State of Wisconsin
Department of Natural Resources

Final Environmental Impact Statement Flambeau Mining Co. — Copper Mine Ladysmith, Wisconsin

March 1990

Figure 2-9
Intermittent Streams and Wetlands

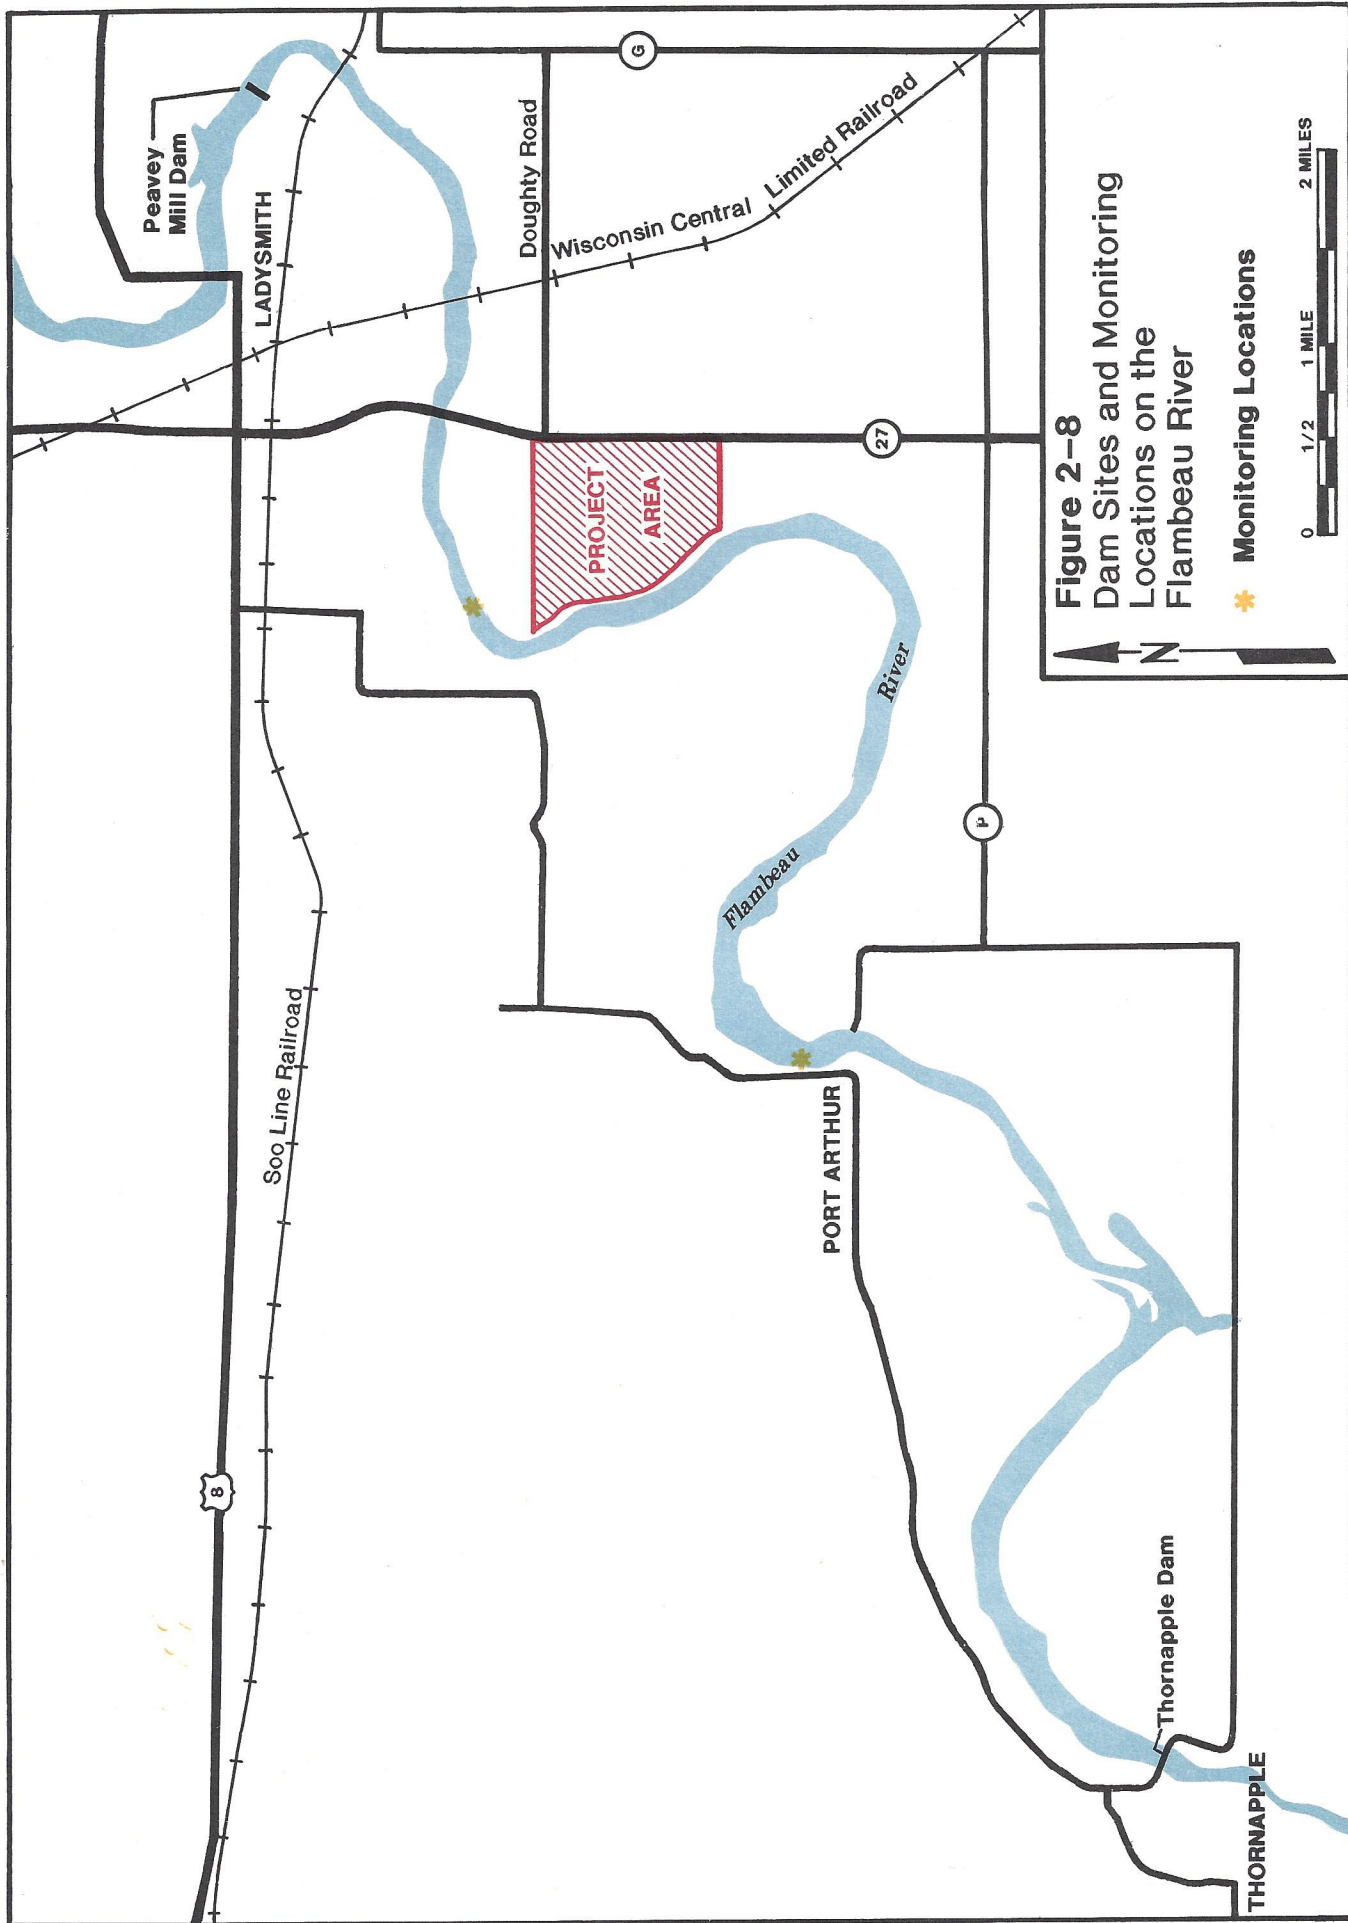
77. Figure 2-9. Add numbers identifying individual wetlands and draw in boundaries delineating these more clearly. [TE]
78. Table 2-1. It is not clear how this table was derived. Are these standards specific to the Flambeau River? It would be useful to have high, low, and mean levels measured in the river from current monitoring programs. [SN]
